NUMBER: 09-010-06

GROUP: Engine

DATE: September 16, 2006

Multiple Cylinder Misfire Or Rough Idle

Fig. 2 LX MODELS - MAP SENSOR

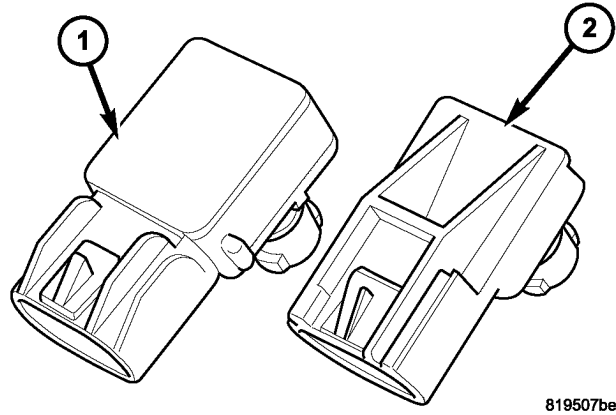
1. Inspect the MAP sensor (Fig. 2) for LX models or (Fig. 3) for CS models.
 - a. If the MAP sensor is the new style, no further action is necessary for the MAP sensor. Proceed to Decarboning Combustion Chamber and Valves.
 - b. If the MAP sensor is the old style, proceed to the next step.

2. Replace the MAP sensor with p/n 05033310AC for LX models or p/n 04896003AB for CS models. If the vehicle is a CS model, be sure the new sensor opening is facing a downward direction when installed and only use one fastener. Refer to the detailed service information available in TechCONNECT, under: Service Info > 14-Fuel System > Fuel Injection > MAP Sensor > Removal and Installation. When complete, proceed to Decarboning Combustion Chamber and Valves.
